ADDENDUM NO. 05

Murrieta Mesa High School New Classroom Building – DSA 04-118451 MURRIETA VALLEY UNIFIED SCHOOL DISTRICT

Project No - 02132020
DSA No. - 04-118451

3 RAILING POST @ HANDRAILS
A9.17 3" = 1'-0"

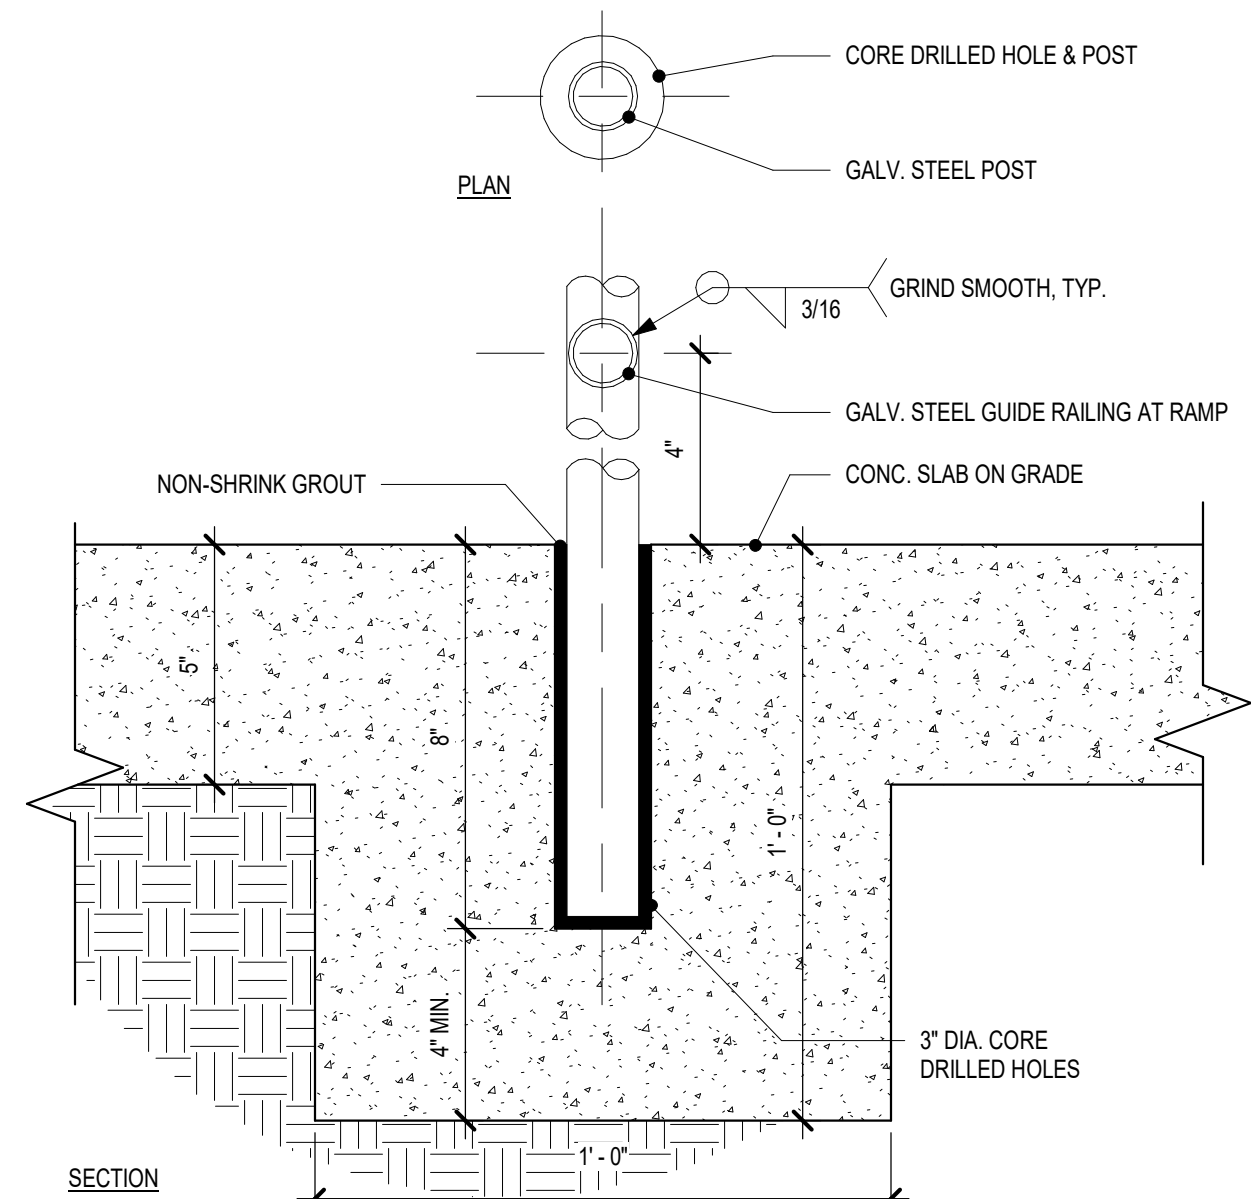
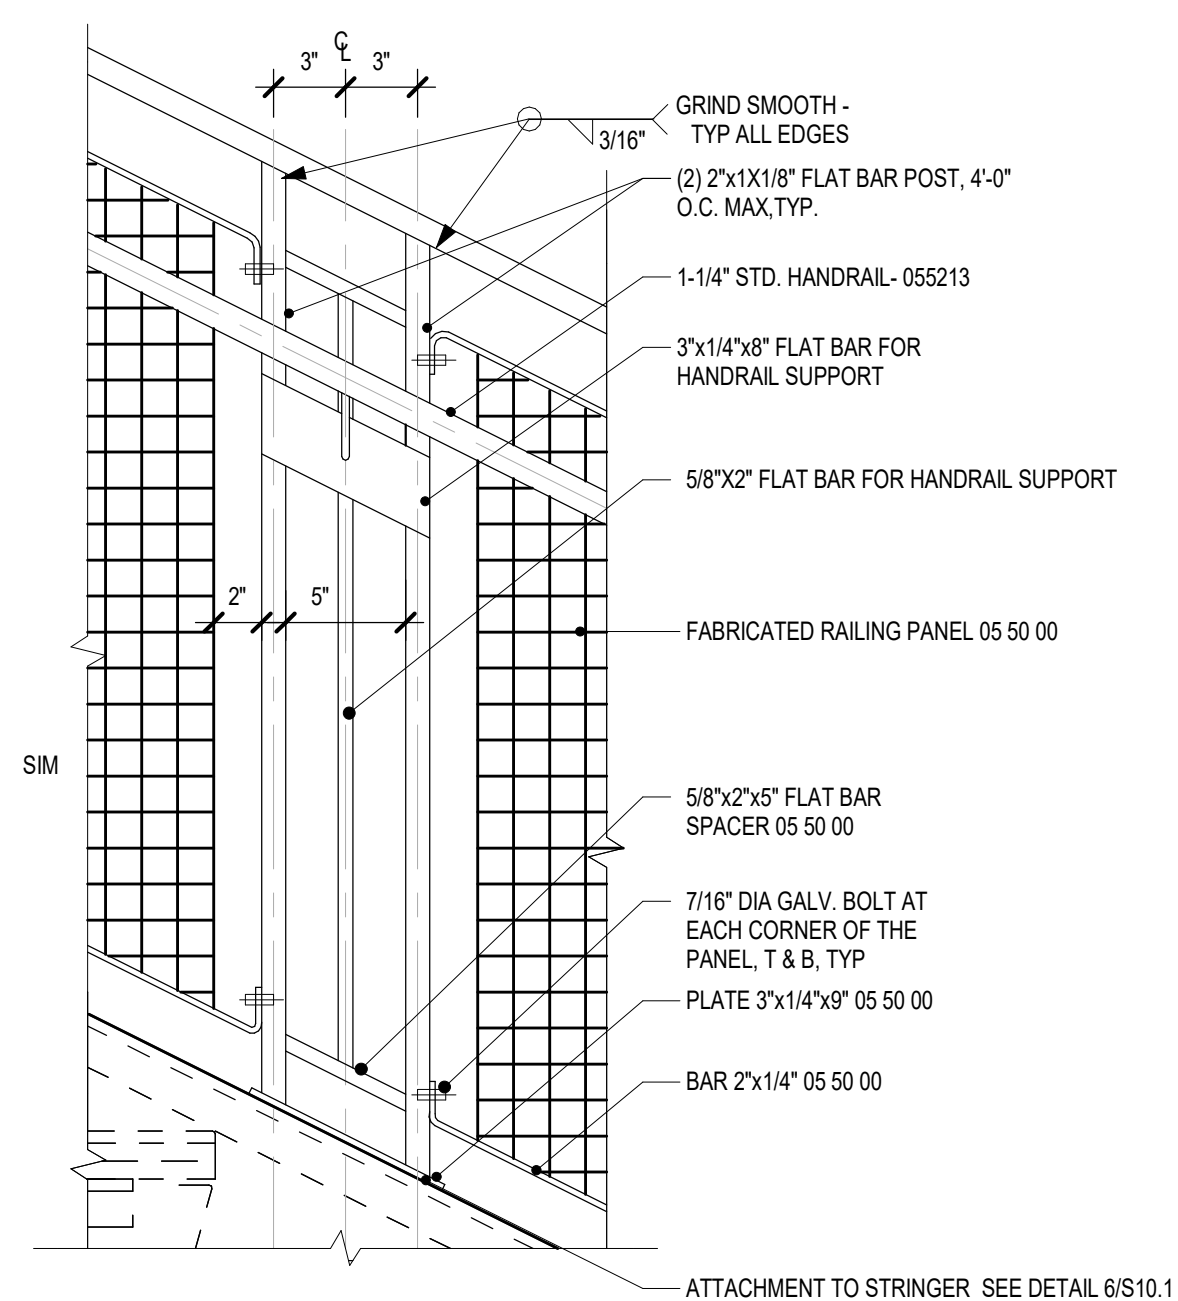
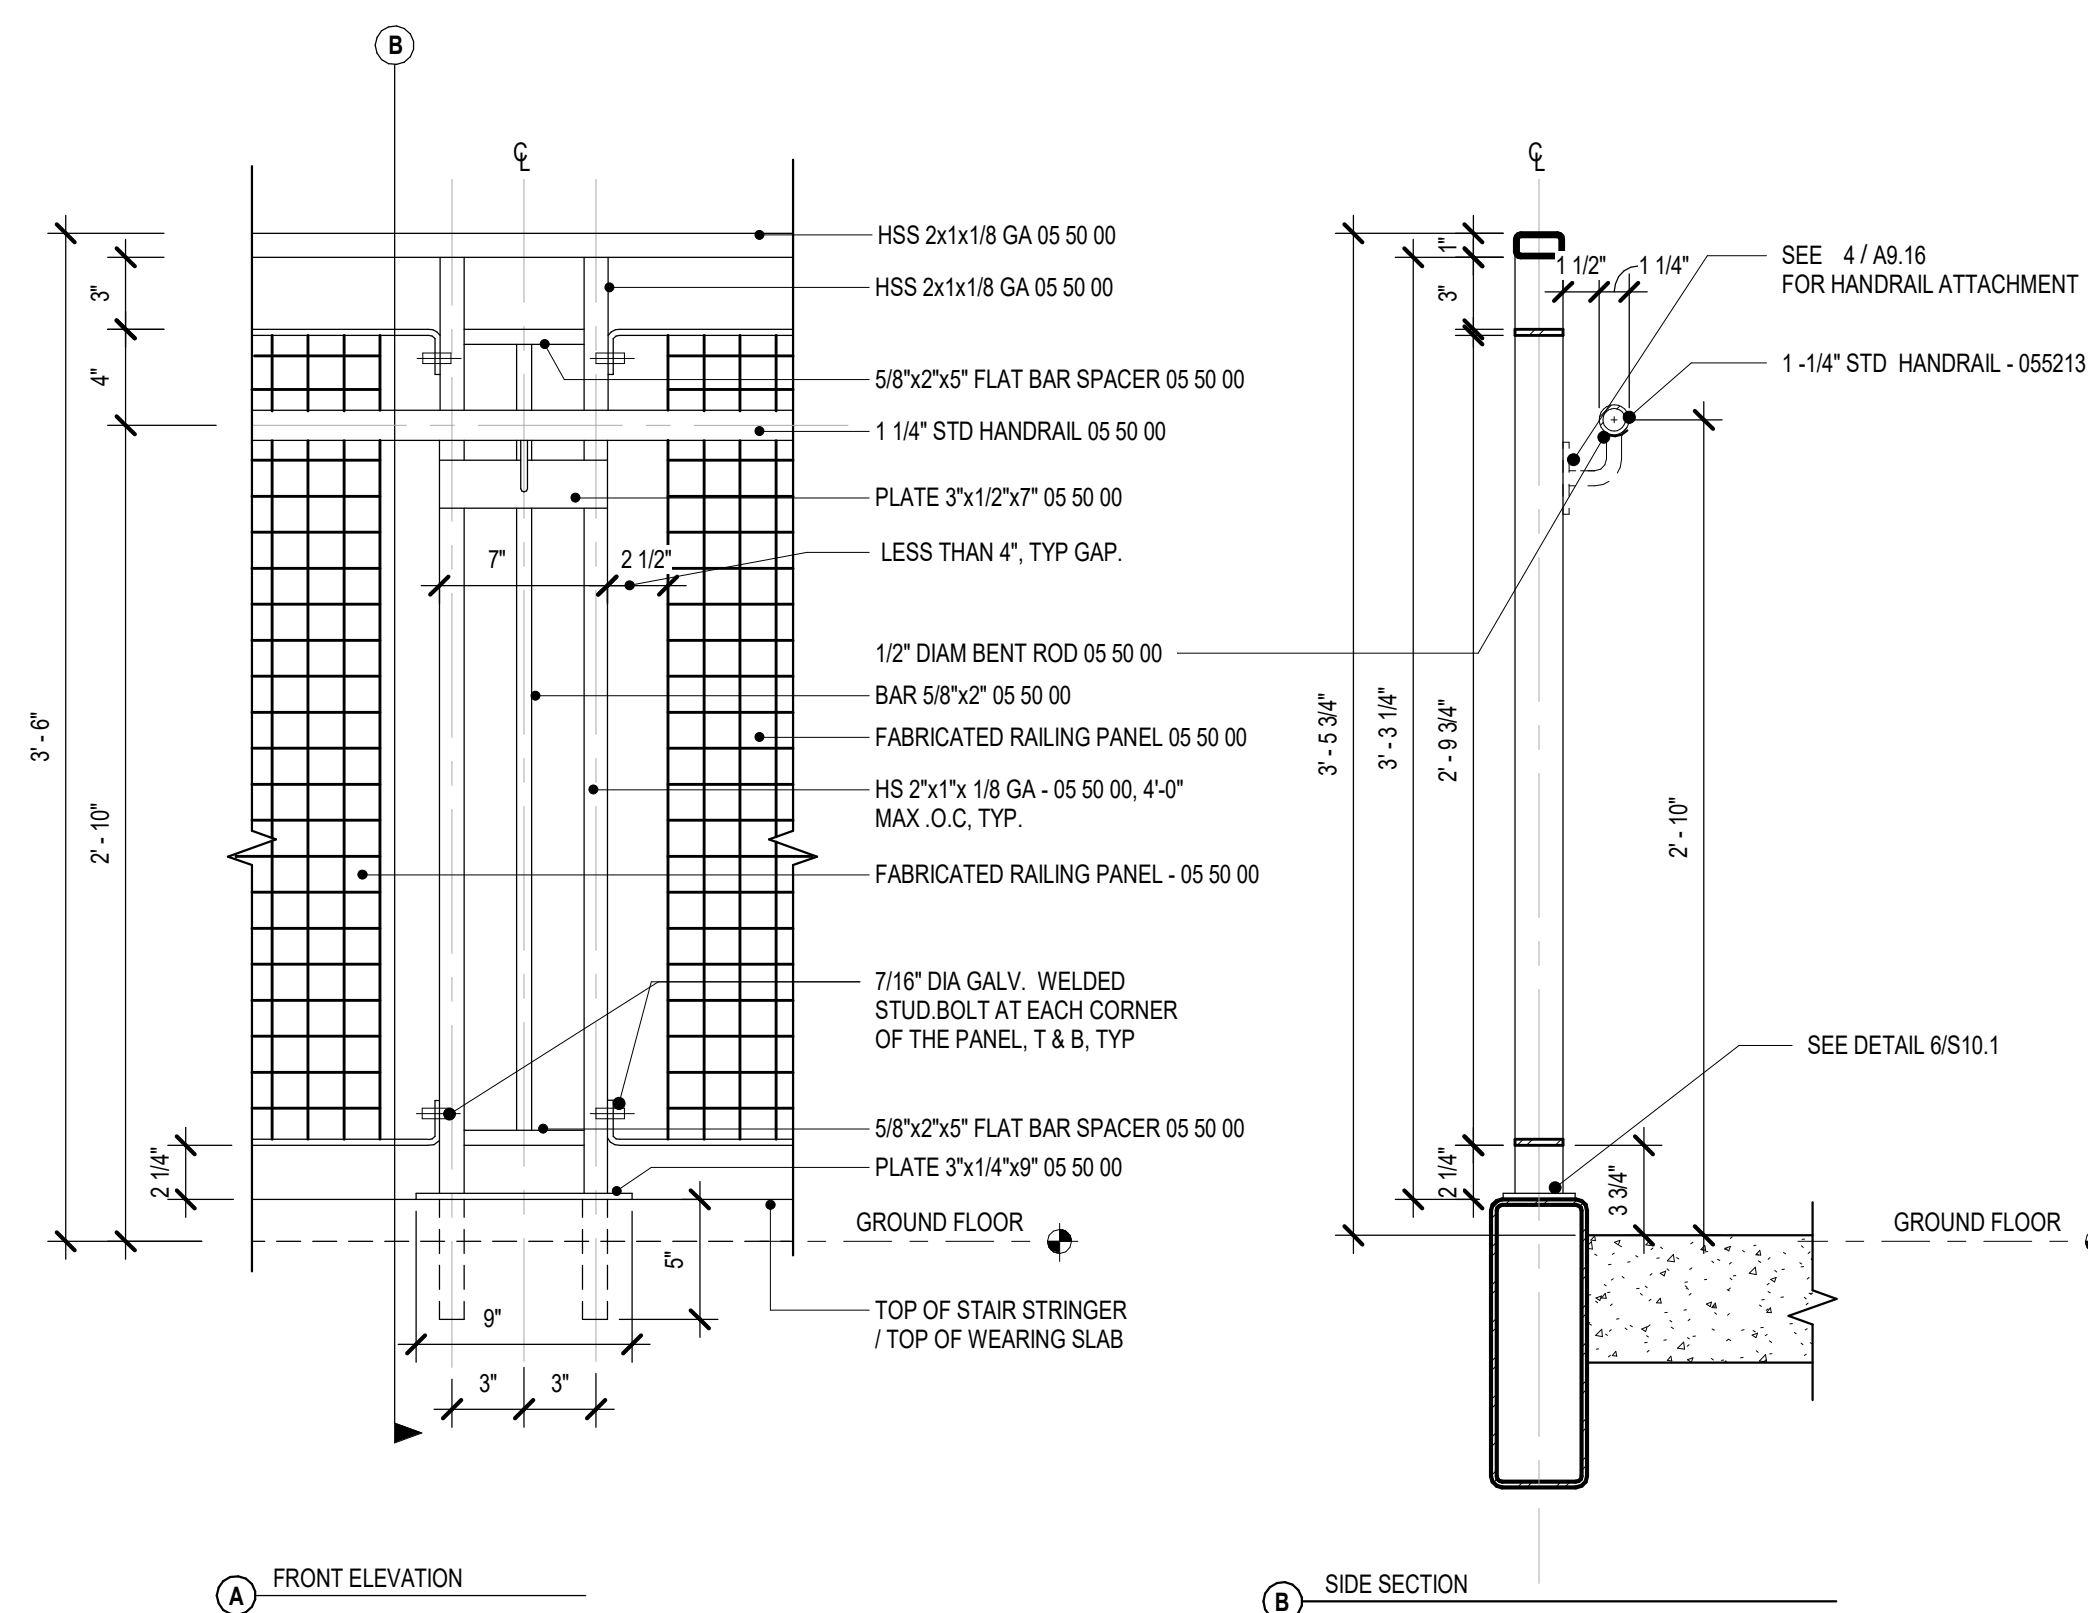
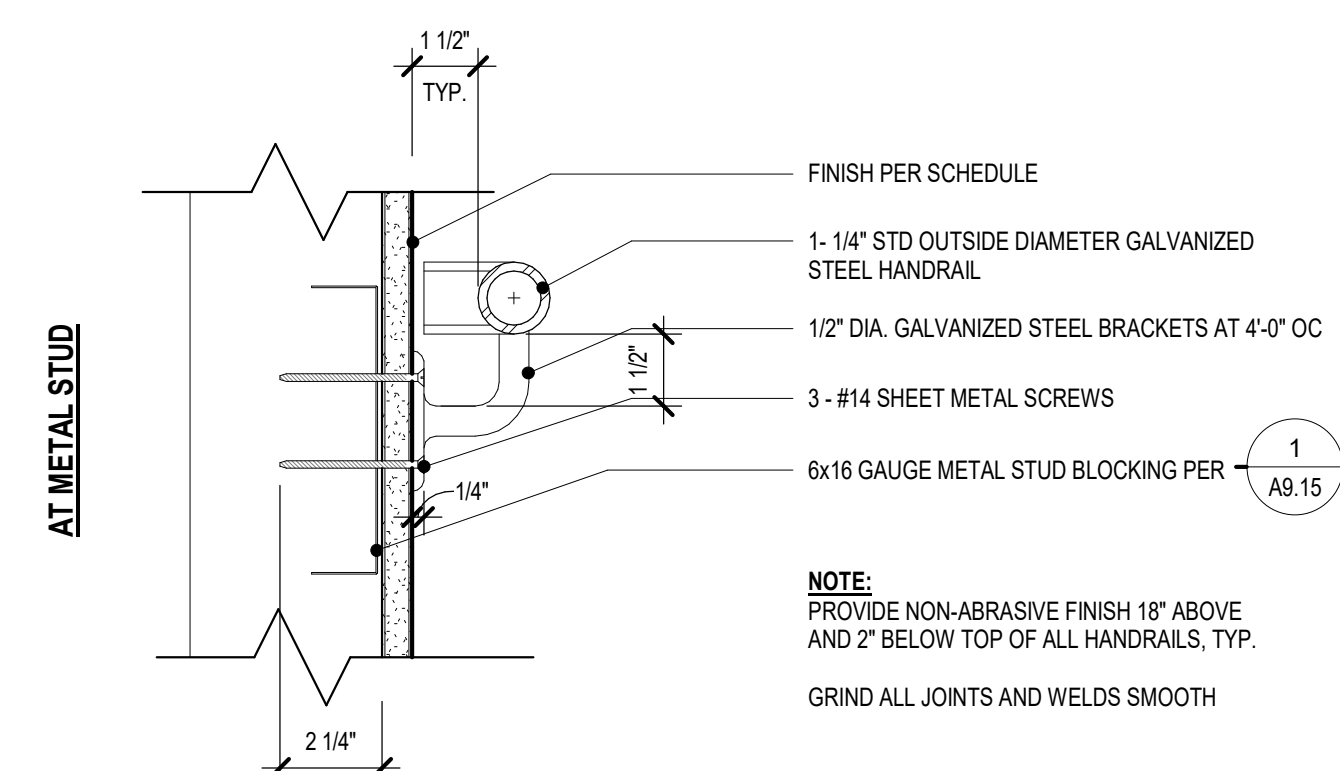
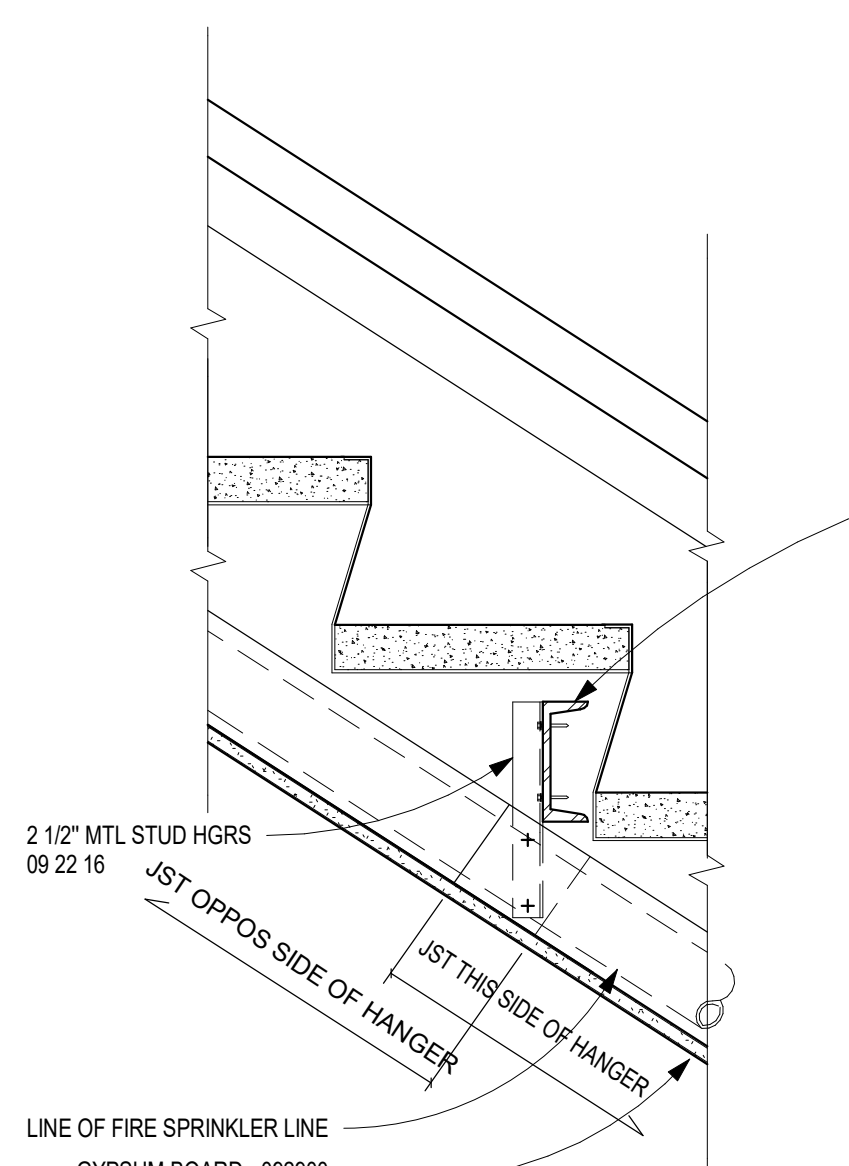
b. SHEET NO. A9.17 / DETAIL 6

Revise currently issued drawing per AD5-A15.
